**TUSCARAWAS COUNTY COMMISSIONERS  
TUSCARAWAS COUNTY, OHIO**

**CONTRACT 2 – WILKSHIRE HILLS WATER SYSTEM IMPROVEMENTS**

**ADDENDUM #3**

**THRASHER PROJECT #101-010-01120**

**PRESSURE FILTER BACKWASH WATER SUPPLY TANK**  
 NOT TO SCALE

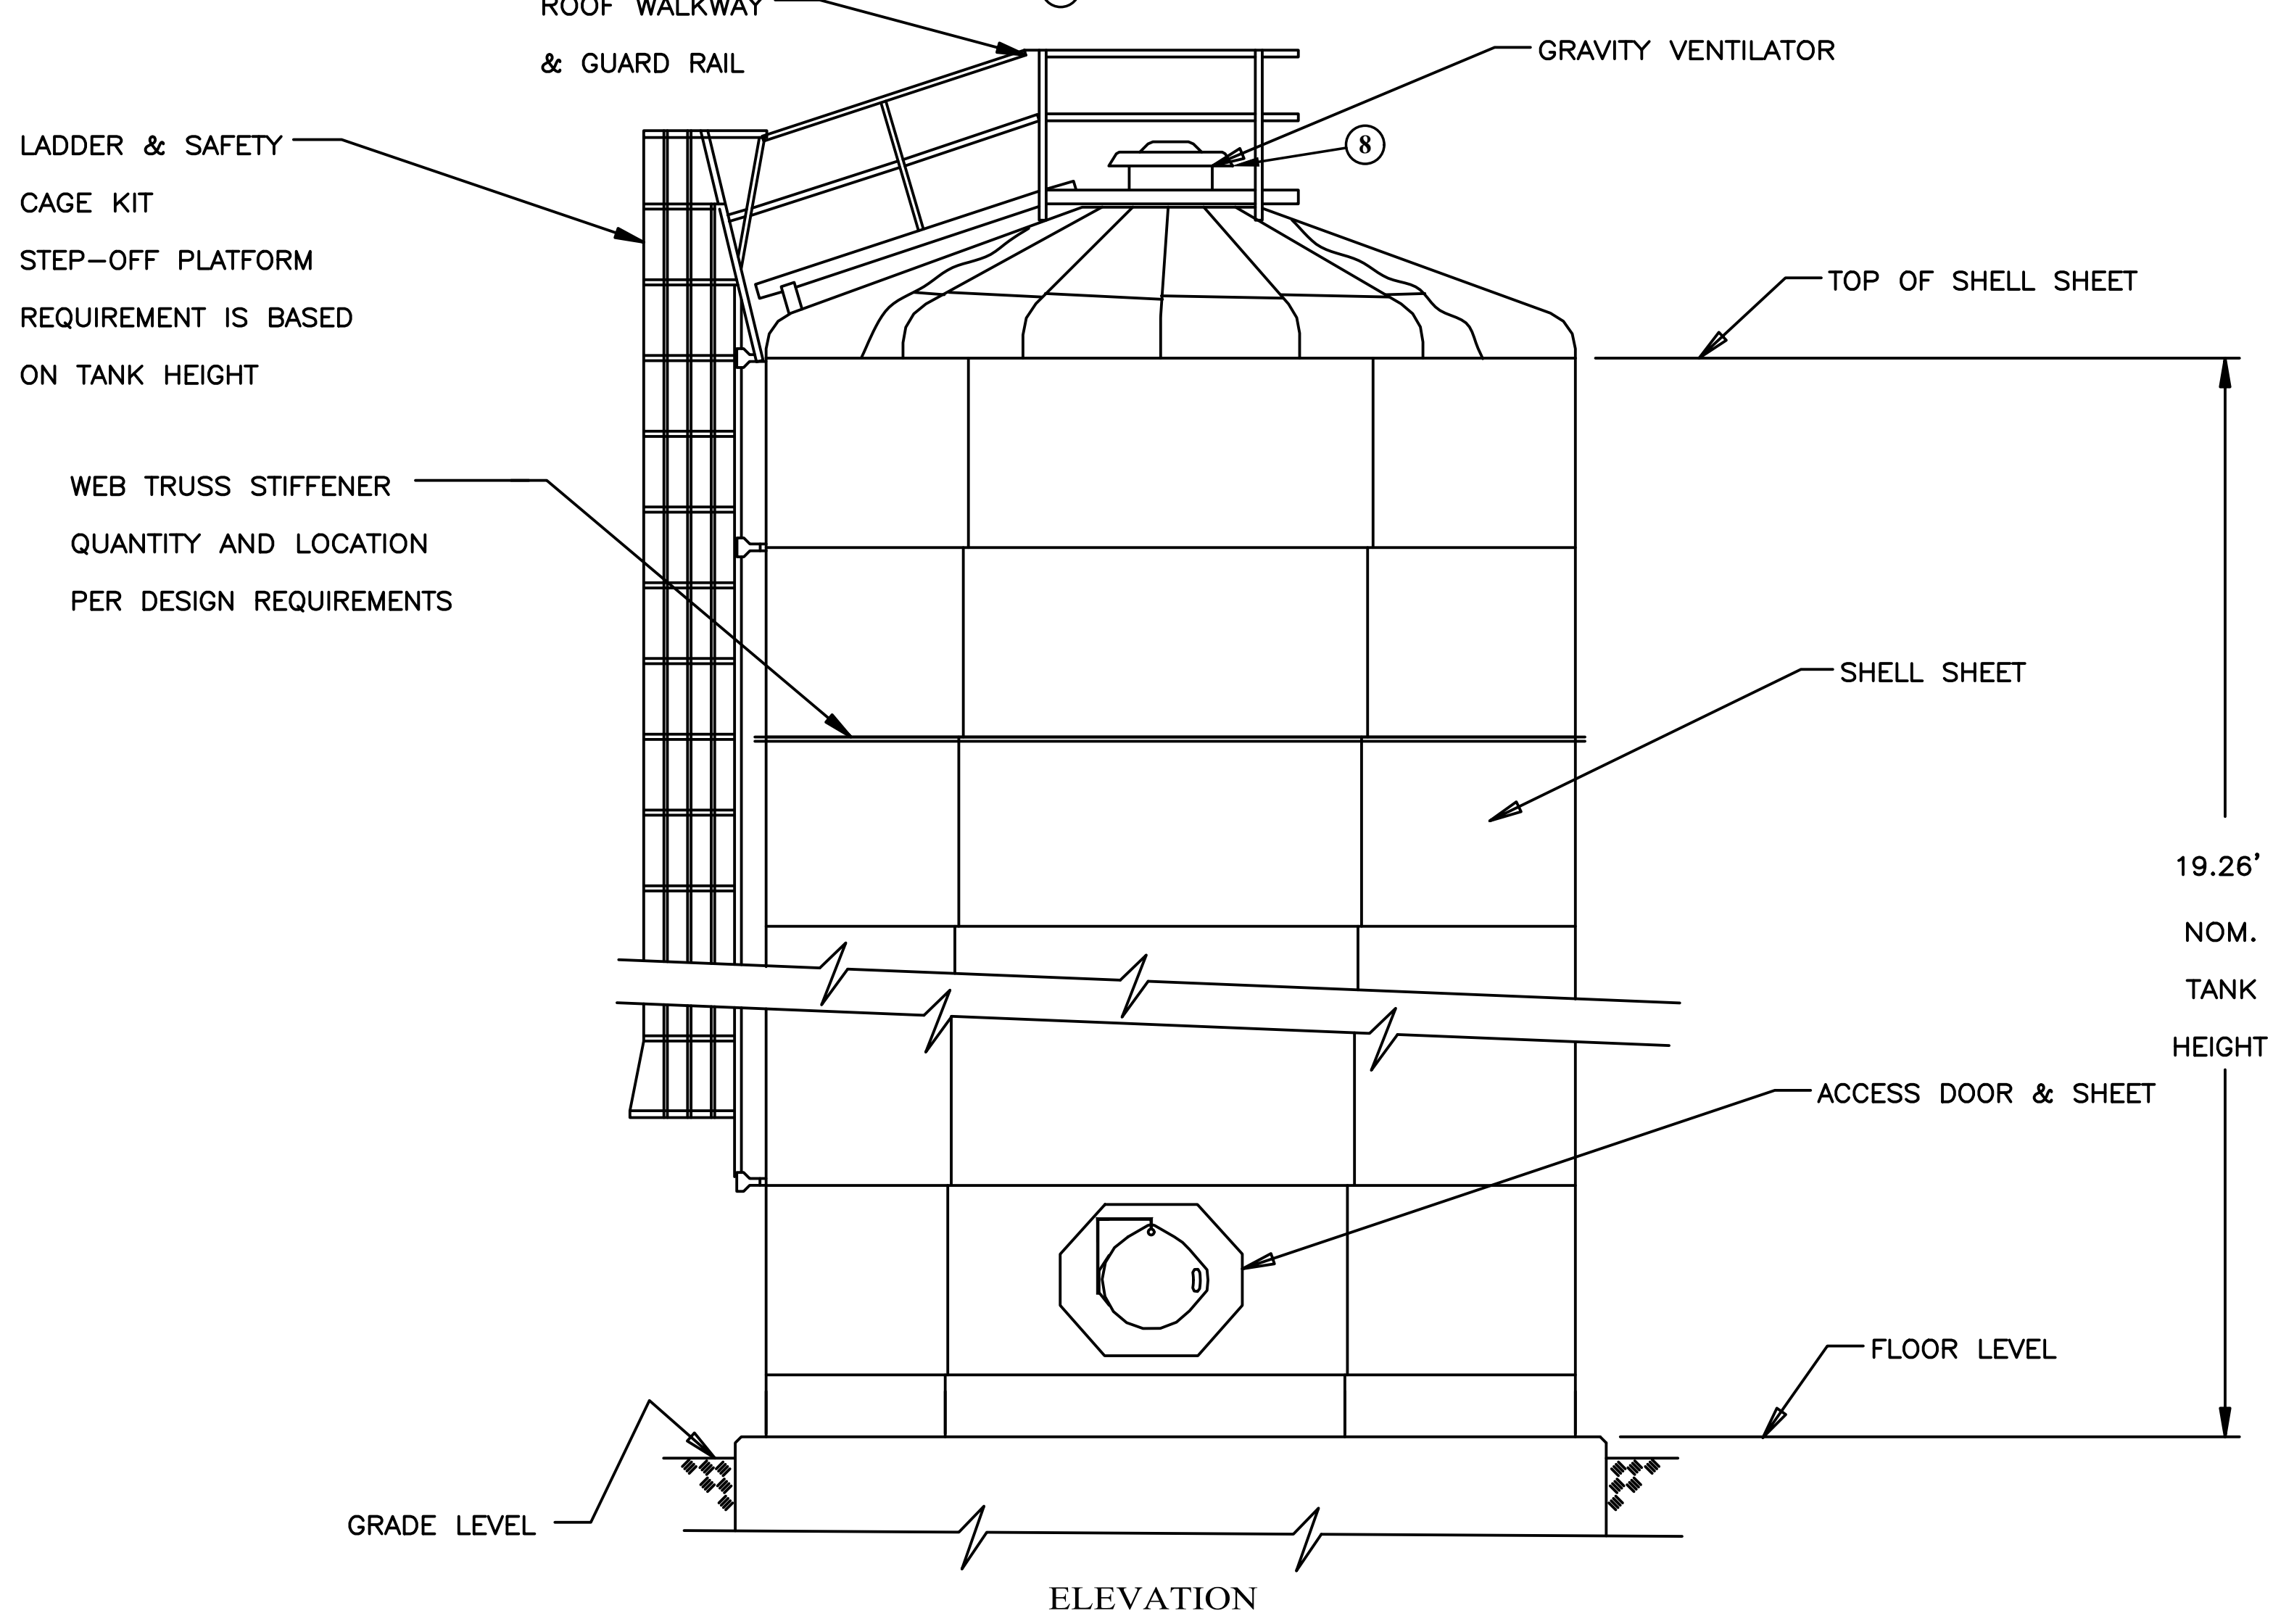
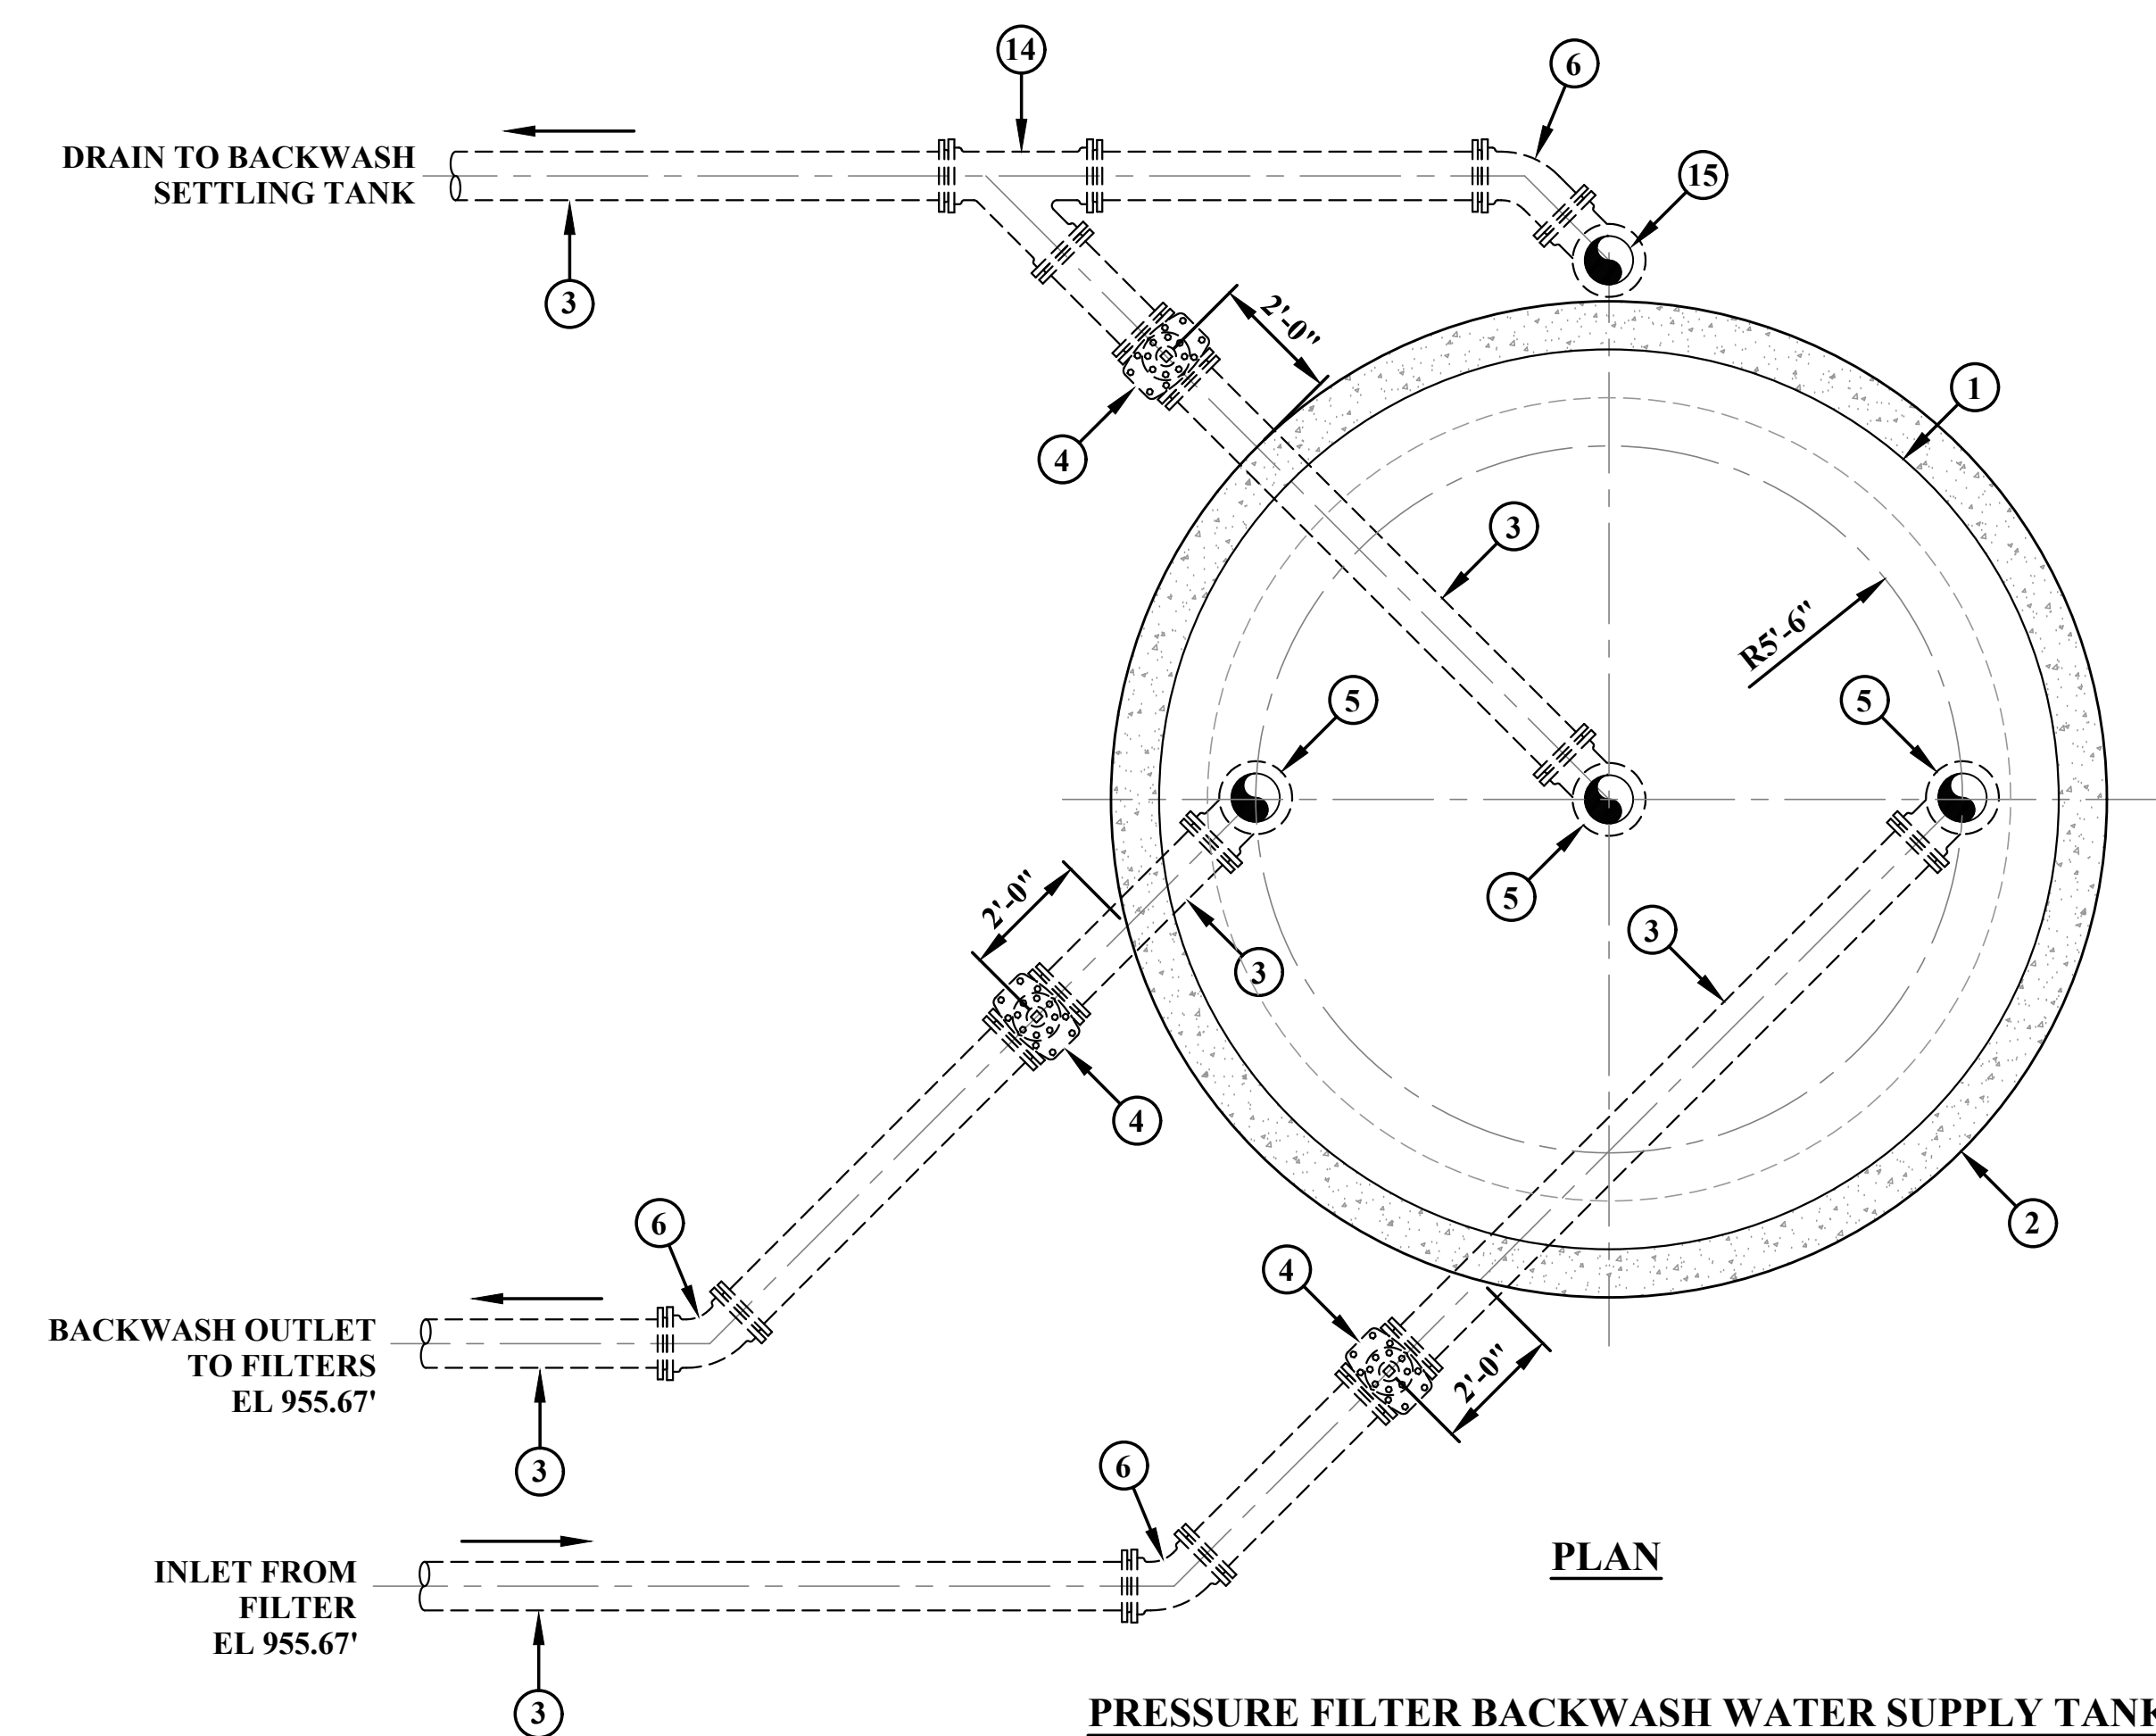
1. **GENERAL**  
**REPLACE** page 5 of the Index with the attached. Revised the name of spec. 331613.
2. **SPECIFICATIONS**  
**REPLACE** Specification 331613 Above Ground Water Utility Storage Tanks with attached Specification for Glass-Coated, Bolted-Steel Potable Water Tank AWWA Design.
3. **DRAWINGS**  
**REPLACE** Sheets 9 and 9A with the attached Sheets 9 and 9A.
4. **QUESTIONS & RESPONSES**

NO.	BY	DATE	QA/QC REVIEW	DESCRIPTION
3	SMD	1MAR2023		REVISED TANK DESIGN & SPECS
2	SMD	11JAN2023		TUSC. COUNTY REVIEW
1	SMD	8DEC2022		QA/QC REVIEW
